T10/06-470 revision 2

Date: November 16, 2006

From: George Penokie (IBM)

Subject: SAS-2: Transport layer read data flowchart

Figure 1 — Representation of transport layer (i.e., ST_TTS1 and ST_TTS3) read data operation

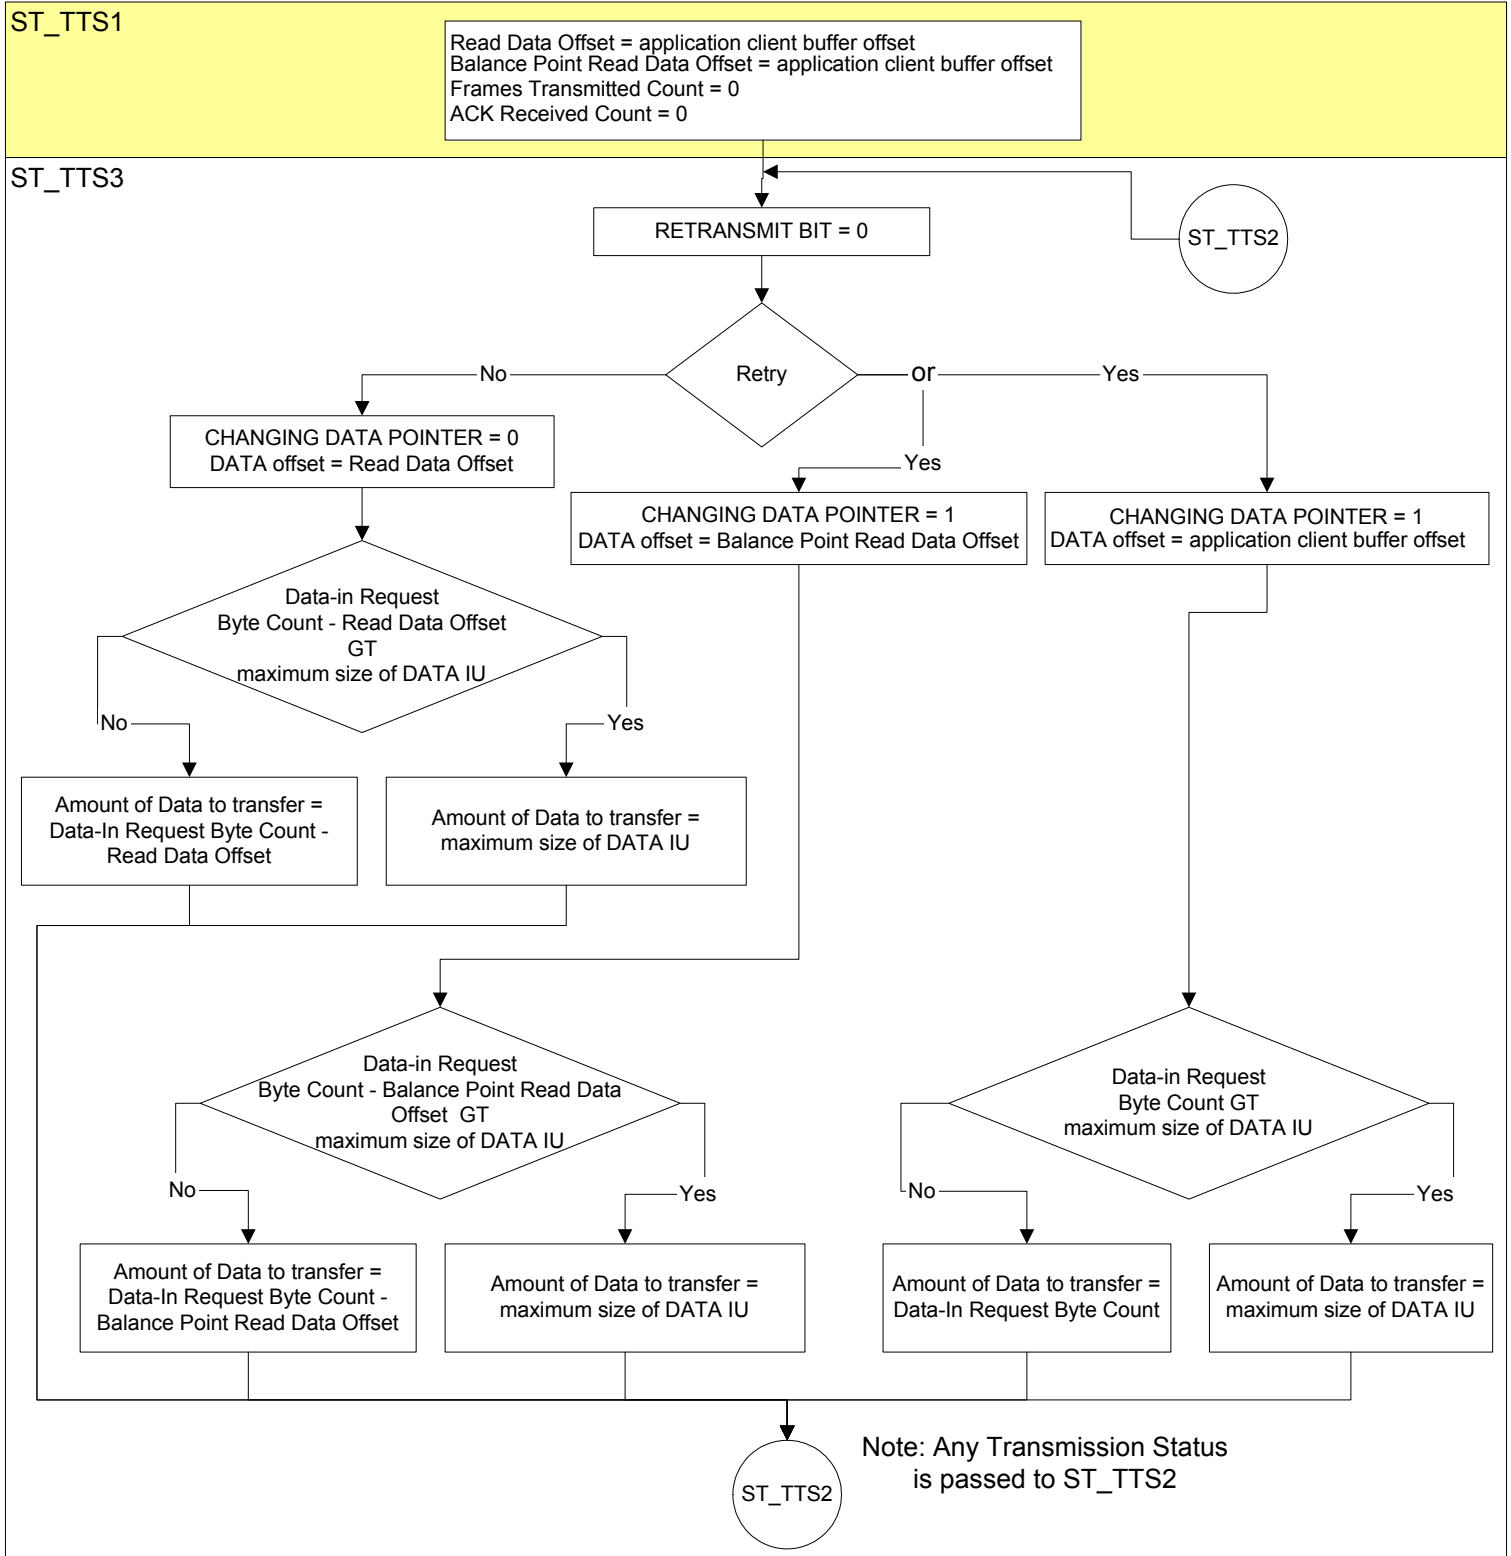
In the process of converting the words that are currently in SAS-2 there were no errors found, however, some of the wording may be somewhat unclear. Also, it was discovered that one of the conditions described in ST_TTS3 can never happen and another is already checked in ST_TTS2 so this proposal is recommending that they be deleted. See below the flowcharts for the suggested changes.

Upon entry into this state, this state shall set the Read Data Offset state machine variable to [the Data-In application client buffer offset argument](#)~~zero~~.

Upon entry into this state, this state shall set the Balance Point Read Data Offset state machine variable to [the Data-In application client buffer offset argument](#)~~zero~~.

[Upon entry into this state, this state shall set the Frames Transmitted Count state machine variable to zero.](#)

[Upon entry into this state, this state shall set the ACK Received Count state machine variable to zero.](#)
